Eddy Building – Detached Addition : Addendum #3

ADDENDUM #3:

This Addendum No. 3 forms a part of the Contract Documents and modifies the original Drawings and Specifications dated September 6, 2024, as noted below. Acknowledge receipt of this addendum in the space provided on the Bid Form. Failure to do so may subject bidder to disqualification.

1 SLAB PLAN
1/8" = 1'-0"

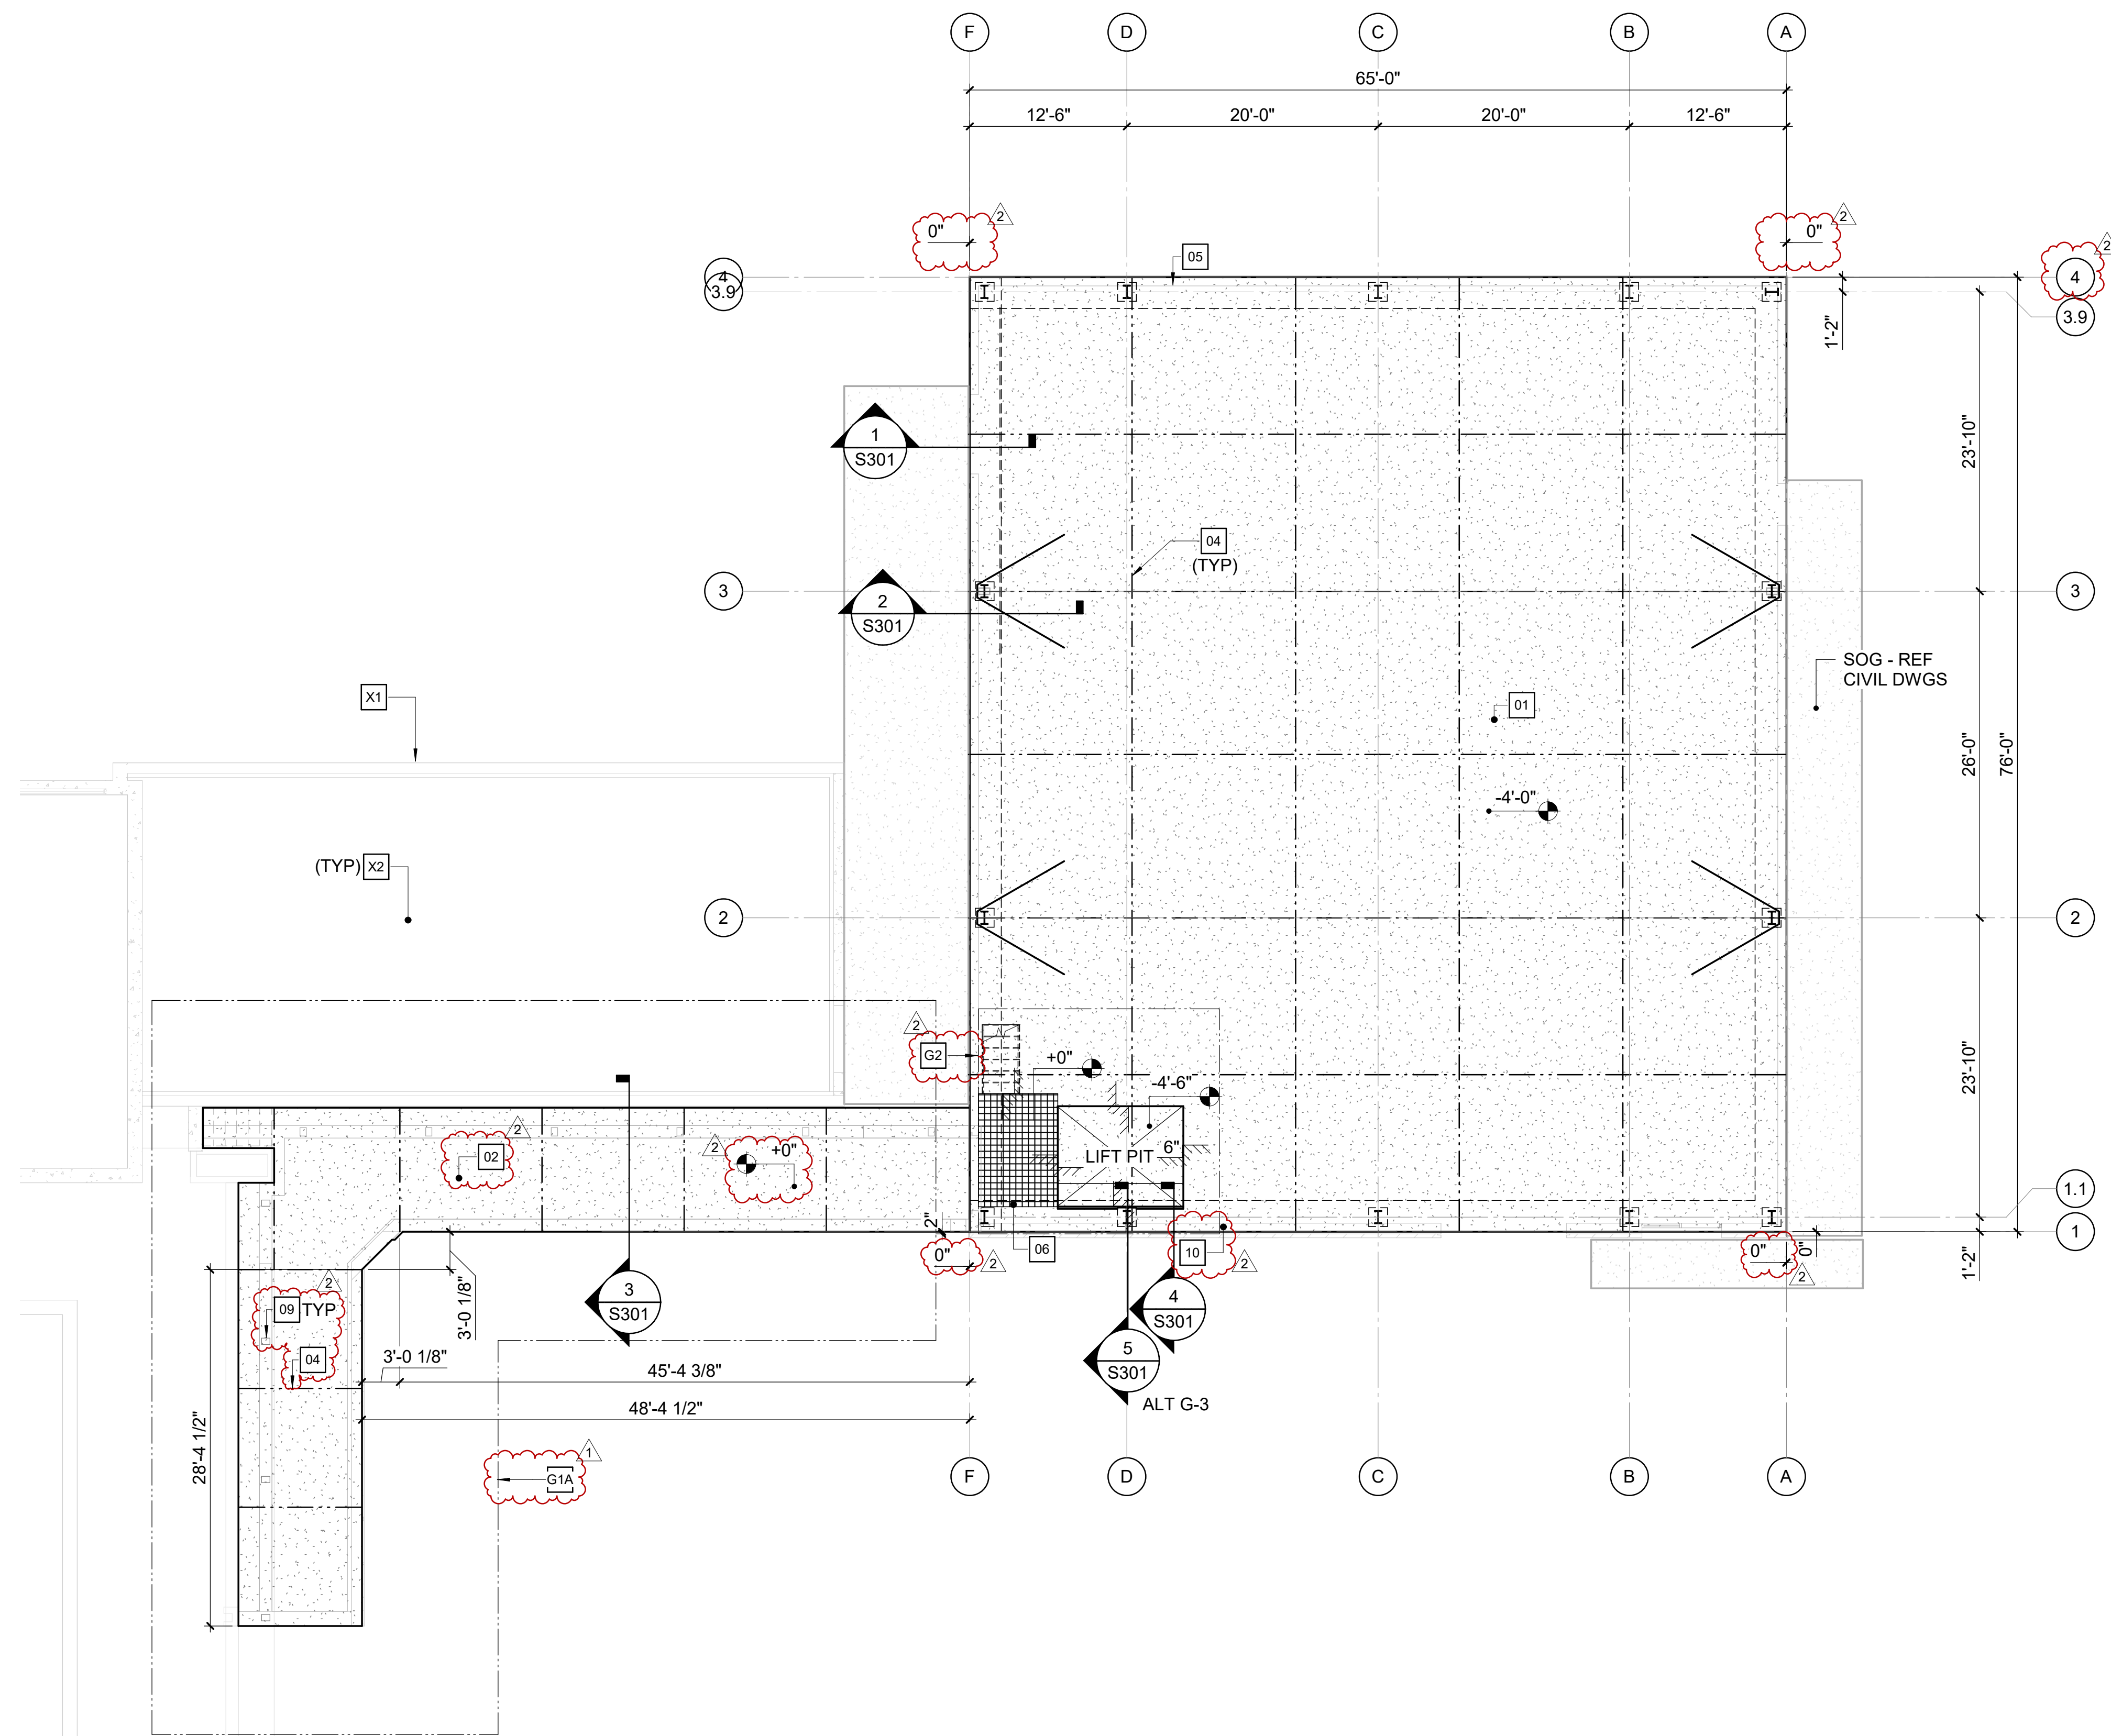
20. The concrete slab is 1 ¼ » larger than the grid lines of the building. It appears this is for a building with standard metal wall panels. Since we are using insulated metal panels, should that dimension be increased?

1. RESPONSE: This has been corrected on the revised structural drawings included in this addendum. The slab edge is to align with the gridlines around the perimeter of the building as shown in detail 3/A-501.

S112

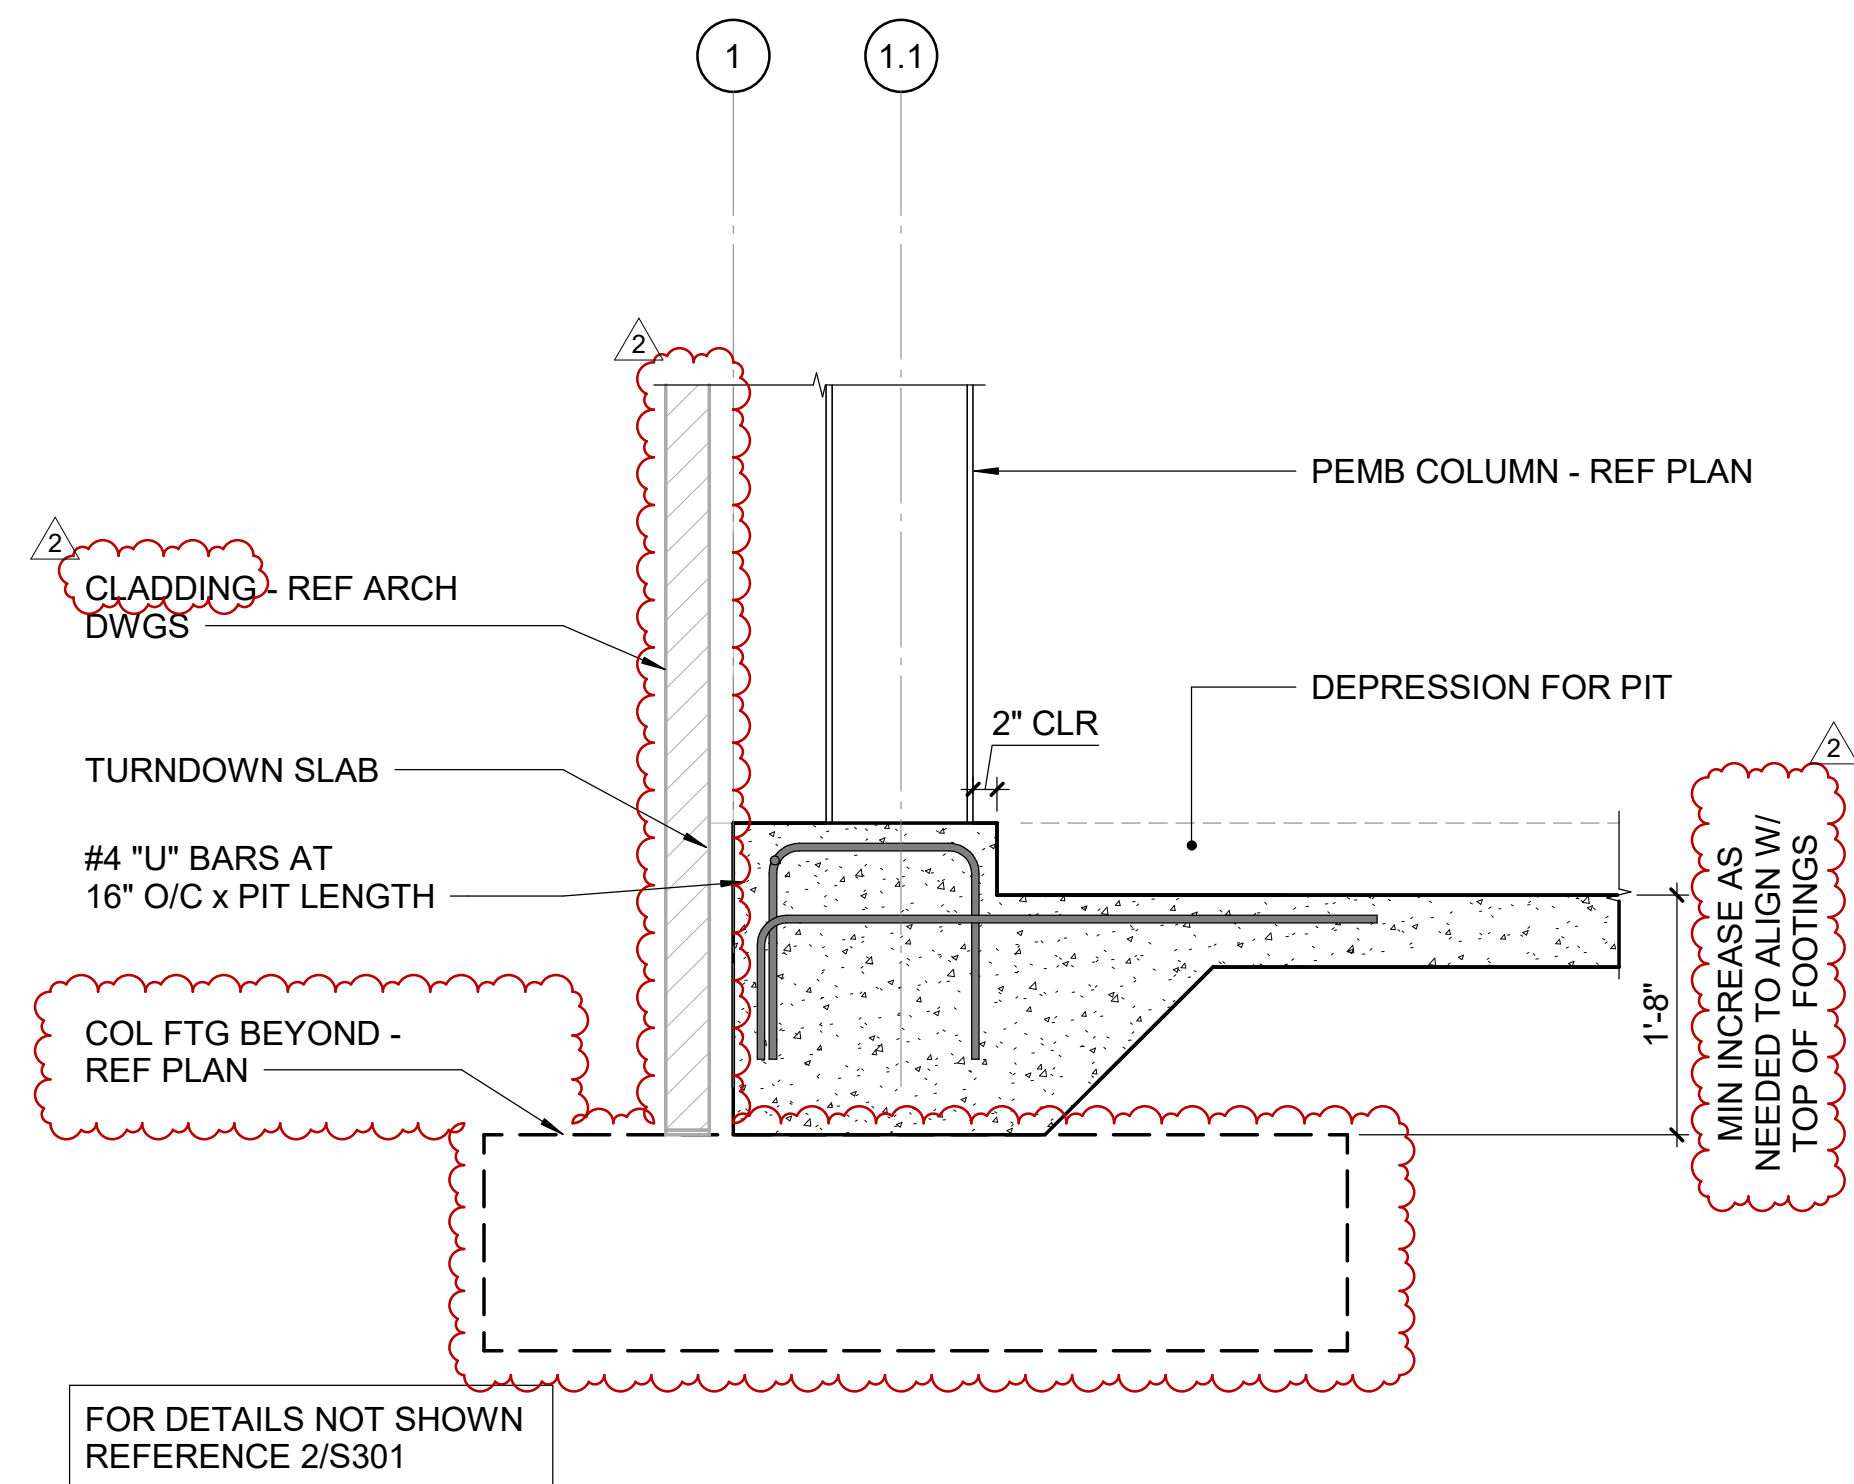
1. RESPONSE: This was answered in Addendum #2. All interior drywall was removed from the project.
19. There is a key note 2 on S112 but we are not seeing it on the plans. Please clarify.

1. RESPONSE: Keynote is clarified on revised structural plans included in this addendum. Keynote 02 refers to the loading dock slab. See revised drawings.
